# TECHNICAL MEMORANDUM NO. 2 TO FINAL PHASE I RFI/RI WORK PLAN

## MODIFICATIONS TO FIELD ACTIVITIES

ROCKY FLATS PLANT  
SOLAR EVAPORATION PONDS  
(OPERABLE UNIT NO. 4)

MARCH 1993

FIGURE 3-2  
 RANDOM SURFICIAL  
 SOIL SAMPLE LOCATIONS  
 SOLAR PONDS - OU4

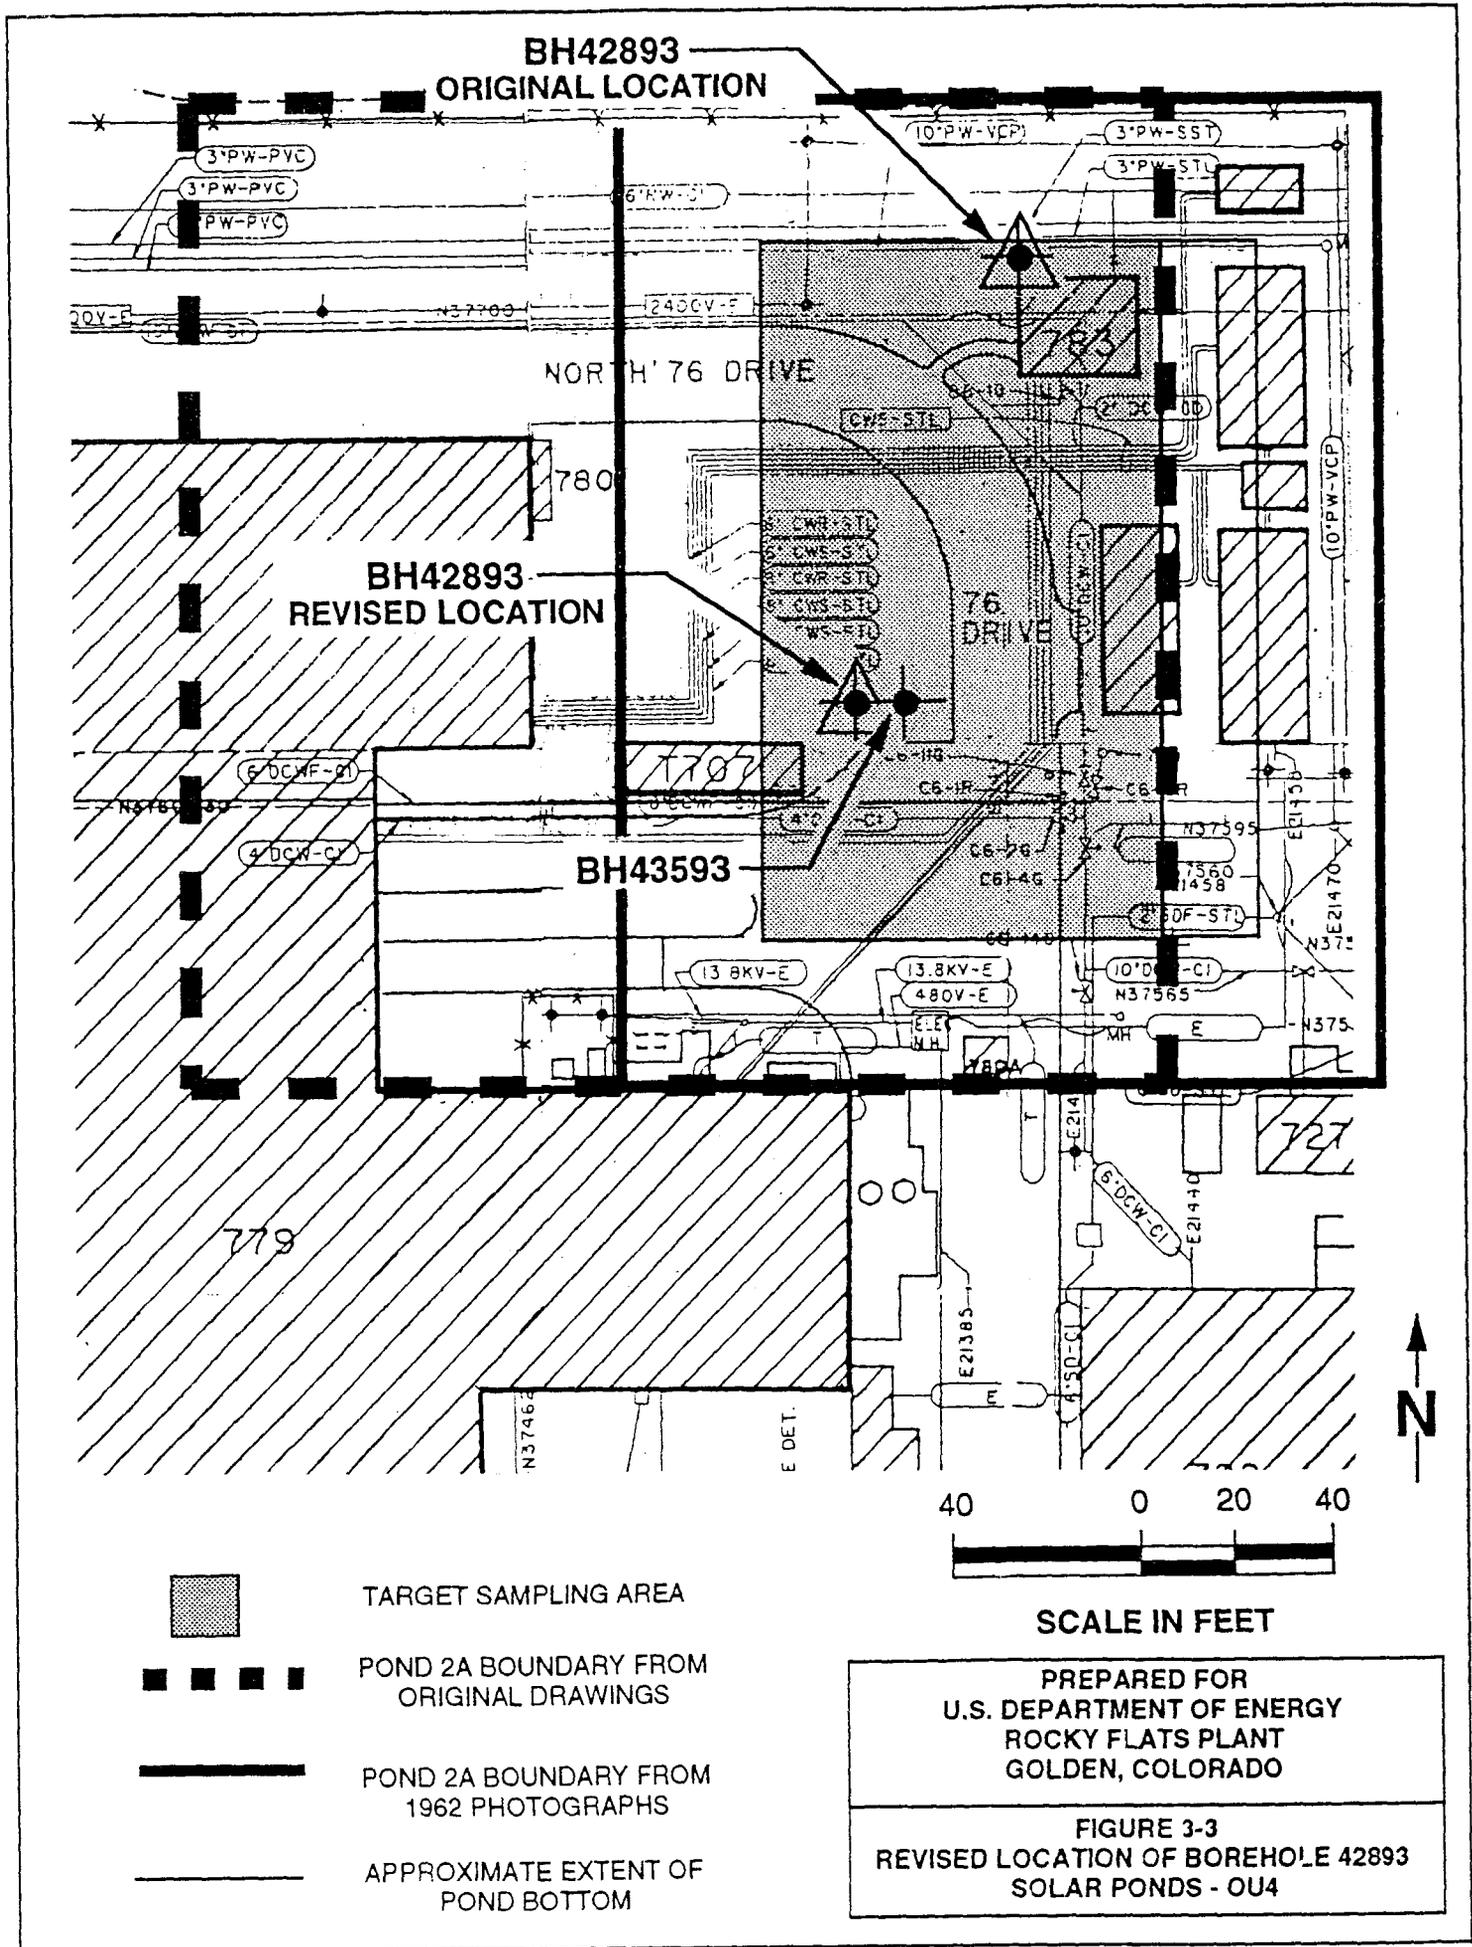
Random surficial soil sample locations were selected using a "simple random sampling" (Gilbert, 1987) methodology. The overall length and width of the OU4 area was determined, and the coordinates of the 25 random surficial soil samples were selected using a random number table (Huntsberger and Billingsley, 1981). The coordinates were then compared to areas of inaccessibility and discarded if they fell in areas inaccessible for sampling. Figure 3-2 indicates the surficial soil sampling locations determined from the random generation.

Three of the samples locations generated during random surficial sampling fell inside Pond 207A, an area accessible for sampling, but undesirable due to the need to cut through the pond liner. In addition, the collection of random surficial soil samples under the pond liner would not provide data regarding aerosol contaminant dispersion and could not be compared to

other random surficial soil sample results. Six boreholes in Pond 207A provide an alternative for the collection of six surficial soil samples, one at each borehole location. The grab soil samples can be compared to liner and underlying material analytical results. It is therefore proposed that the random surficial soil samples be moved from within Pond 207A out to the pond perimeters, because surficial soil data will be obtained from borehole locations. The revised locations of proposed random surficial soil samples are also on Figure 3-2.

FIGURE 3-3  
 REVISED LOCATION OF BOREHOLE 42893  
 SOLAR PONDS - OUA

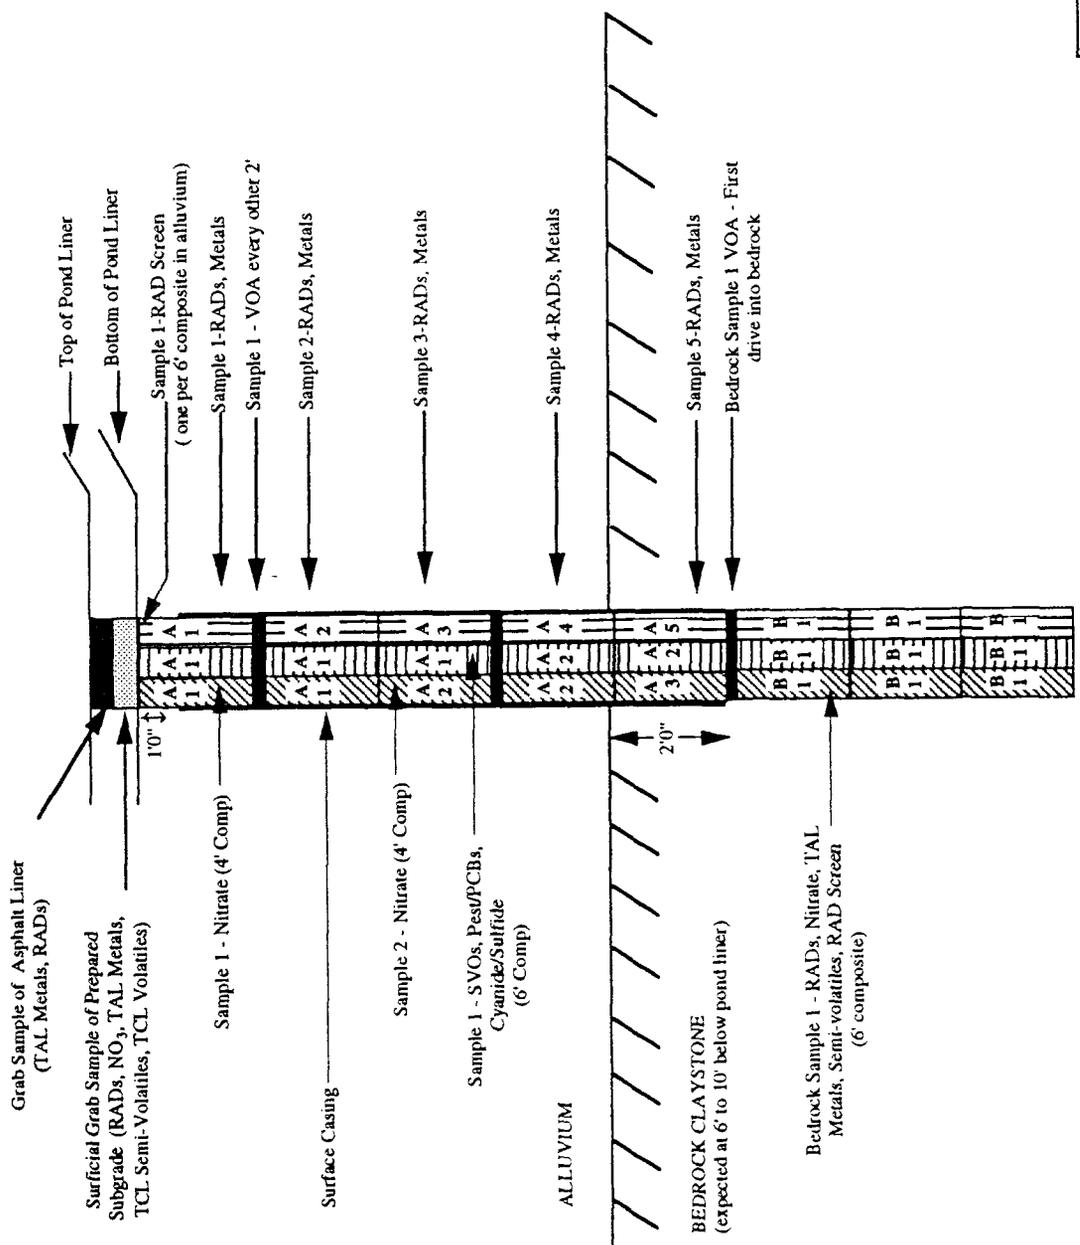
The need for relocation of Borehole 42893 arises from the high density of buried utilities in the area of the originally proposed location. The inability to verify the exact locations of these utilities, especially process waste transfer lines, led to the need to change the location of the borehole as shown in Figure 3-3. Further constraining the location of this borehole is the requirement to remain within the target overlap area defined by the discrepancy between the Pond 2A "as-built" drawings and 1962 aerial photographs of the Original Pond configuration (EG&G, 1993). Remaining within this target area ensures the best chance of encountering any remaining indications of Pond 2A.

conditions. Borehole 42893 is proposed to be instrumented with vadose zone monitoring equipment. The long-term monitoring of pore water chemistry will provide indications of any contaminants that remain within the vadose zone media resulting from the Original Ponds, even though the ponds were abandoned and attempts at remediation occurred in 1962.

PROPOSED SAMPLING PLAN WITHIN  
 POND 207A—BOREHOLE 42193

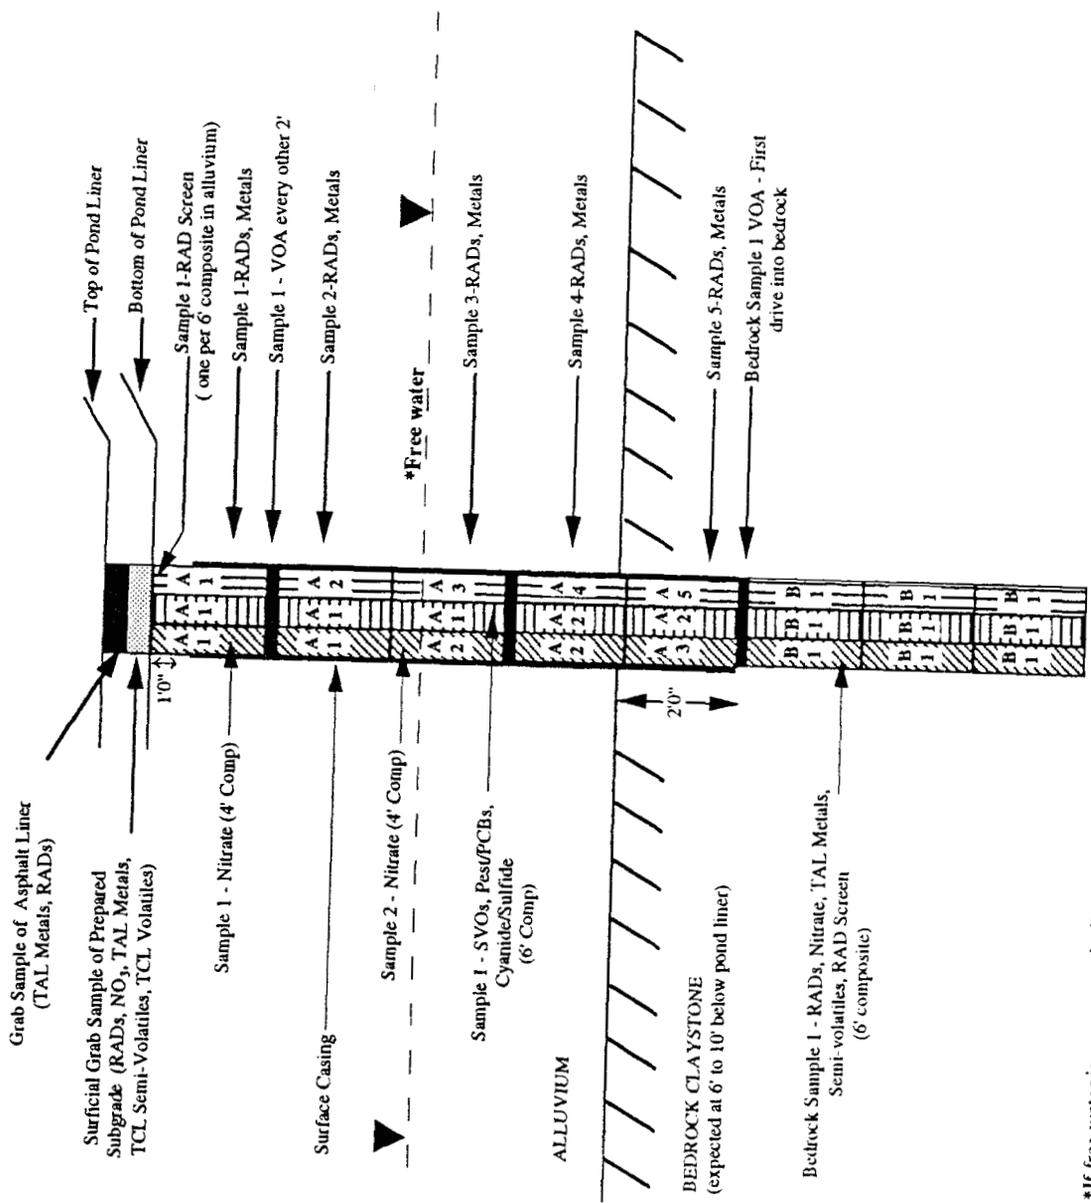
The proposed sampling procedure for Borehole 42193 is presented in Figure 3-4. Sampling of the pond liner and alluvial components of Borehole 42193 are as described in the previous paragraph. Deeper bedrock sampling from this borehole is proposed to be conducted using the standard 6-ft composite intervals throughout the bedrock until either a maximum depth of 50 feet or evidence of sandstone or ground water is encountered. It is preferred that an offset casing be installed in the deep hole to allow geologic logging to proceed with neutron, gamma, and induction tools. The casing will reduce the risk of hole cave-in on the tools, and minimize direct contact of the tool with potentially contaminated materials. Presence of the thin-walled casing will cause minimal interference with the quality of logging results.

FIGURE B-1  
 LOCATIONS OF SOIL BORINGS  
 PRESENTED IN T.M. NO. 1  
 SOLAR PONDS - OU4

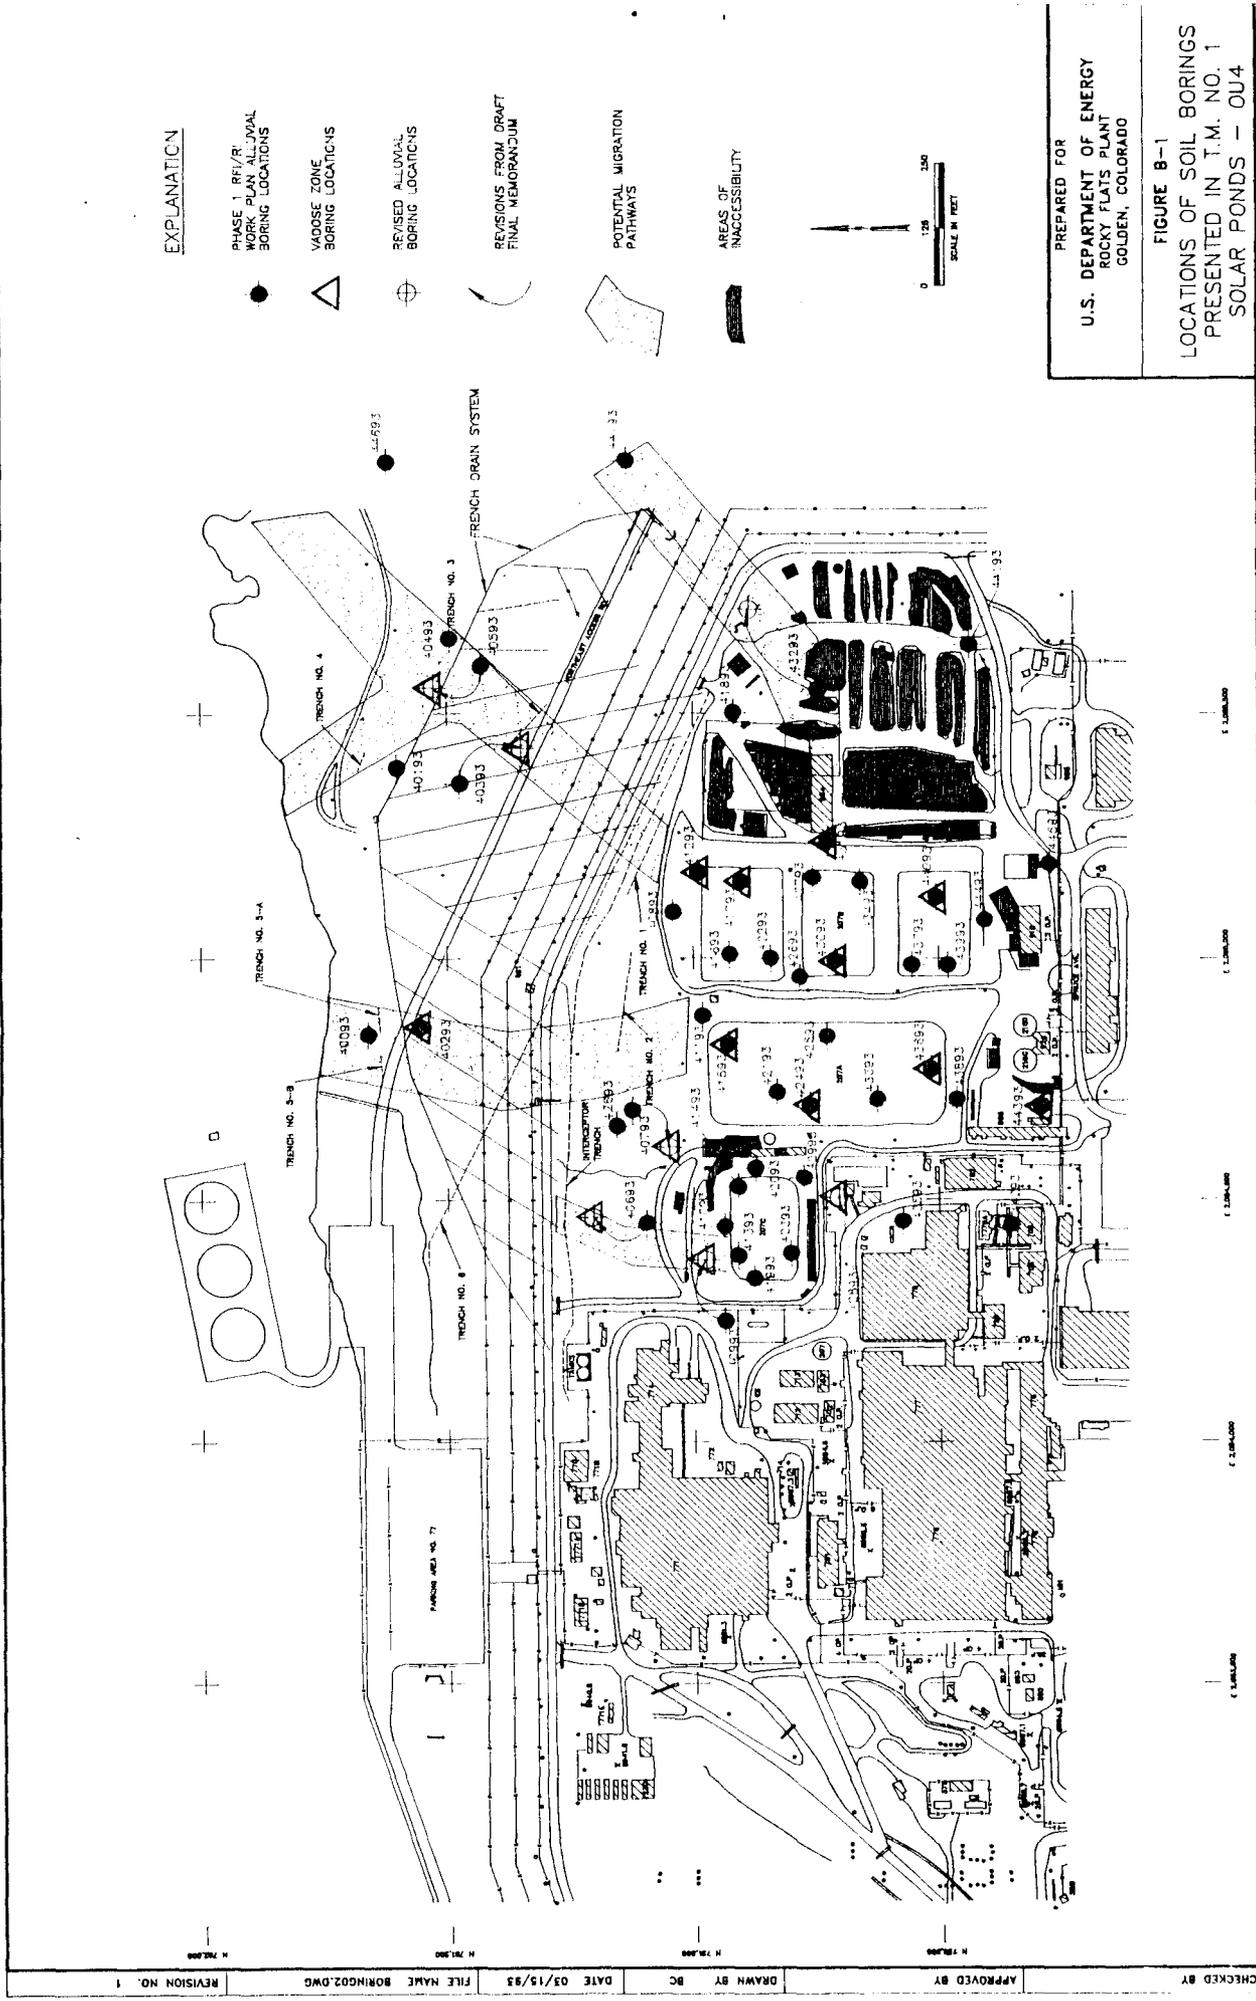
Borehole 41793 has been relocated from its originally proposed location within Pond 207B-North (Figure B-1) to a location near the southeast corner of Pond 207B-North. Data evaluation efforts indicate that a bedrock low exists near the southeast corner of Pond 207B-North, representing potentially the lowest point in the bedrock surface beneath all of the ponds. It is likely that potentially contaminated ground water could migrate in that direction beneath the Ponds. Based on water level measurements from nearby Well 2886, there is an approximate 3-foot average annual fluctuation in ground water in the general location, with the typical high water level approximately 4 feet below the ground surface. Vadose zone monitoring equipment to be installed in Borehole 41793 will monitor the potential contamination in the vadose zone which can be correlated and compared to data generated from an alluvial well in the area. Additionally, the placement of vadose zone monitoring instrumentation in this location is based on the fact that although the typical annual water level high is approximately 4 feet below the surface, a one-time recorded event in the alluvial well in the area indicated the ground water level was within approximately 1 foot of ground surface. Vadose zone monitoring equipment will therefore monitor potential residual contamination introduced into the soil by contaminated ground water and the leaching or removal of this contamination over time.
